Service Bulletin

PRELIMINARY INFORMATION

Subject: Deformed or Dimpled Liftgate Center Applique, Liftgate Paint Damage Evident at Lower Outer Edge of Applique

Models: 2007-2013 Chevrolet Suburban, Tahoe
2007-2013 GMC Yukon Models, Yukon XL Models

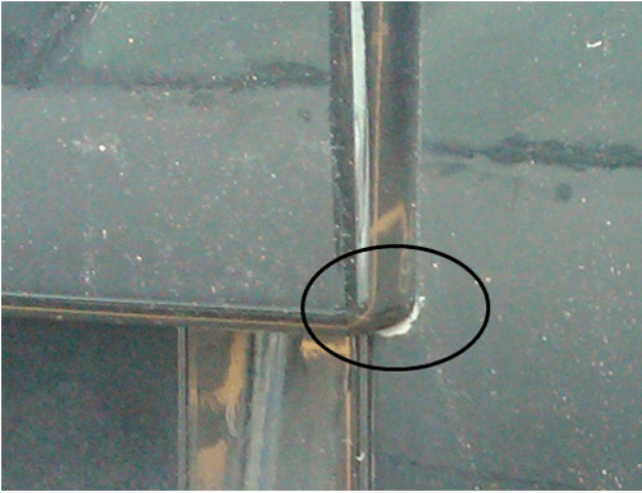
Condition/Concern #1

Some customers may comment on seeing a dimpling or deformation (shown circled above) near an outer edge of the liftgate center applique.

The design of the applique might allow deformation or dimpling of the applique surface if the retaining nuts are overtightened. In some cases, damage to the applique mounting bosses may be evident if the studs were overtightened.

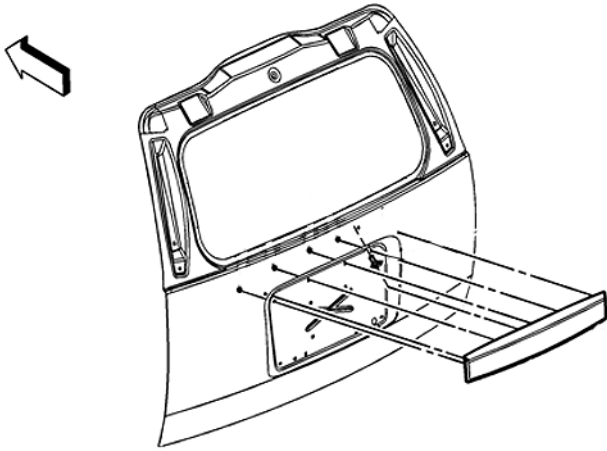
Condition/Concern #2

Some customers may comment on paint damage (shown circled above) on the liftgate at the lower outboard edges of the center applique.

The design of the applique in conjunction with the forming of the license plate pocket in the liftgate may allow the lower outboard edges of the applique to have contact with the liftgate.

The liftgate center applique design has been revised to be more resistant to overtightening, provide enhanced anti-rotation measures for the mounting studs and also provide an improved interface to lessen contact with the liftgate.

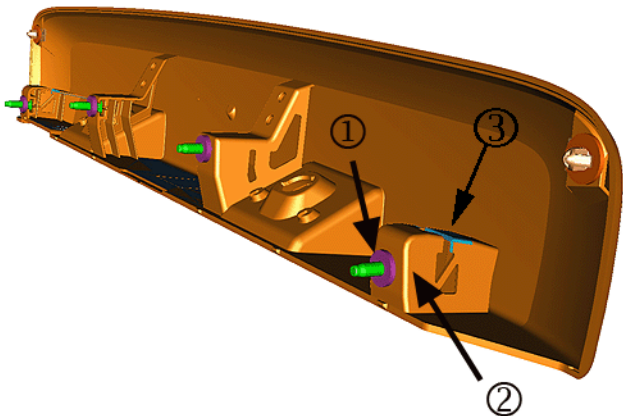
Tip: To correct Condition 2, the updated design applique is necessary, identified by a split along the top of the outer mounting boss locations (3). The updated design applique is already present on 2012 and new vehicles.

Note: P/N 15911310 is a 0.25 mm thick Mylar washer. The recommended guideline is to use four washers at each of the applique mounting stud locations, positioned over the stud, behind the foam washer, to achieve an additional 1 mm of gap between the lower edge of the applique and liftgate.

Additional clearance will need to be created between the lower edge of the updated applique design (3) and the liftgate. Add GM washer P/N15911310 to the applique between the foam washer (1) and the mounting boss (2) at each of the four mounting stud locations. Stack the washers to obtain the needed amount of spacing along the lower edge of the applique to prevent contact to the liftgate, while providing a good appearance.
